## Access Compliance Report Public Rights-of-Way (Curb Ramps)

Intersection ID: 45501 Main Street: BUGGY\_HORSE\_RD Cross Street: CAPTAIN\_ARDREY\_RD Location: S

ADA ID: 9B5C451249E0 Ramp Type: Combination1Diag Initial Pass/Fail: Fail Overall Compliance: No Severity Score: 0

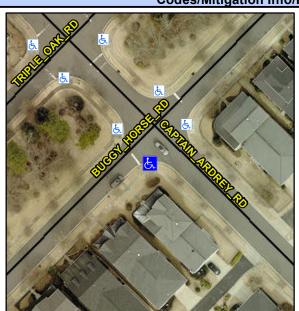
RP & LT RP < 5%

Not Found, R304.5.1, R304.2.2, R304.5.3

Remove & Replace Curb Ramp With Two New Directional Ramps or Equivalent.
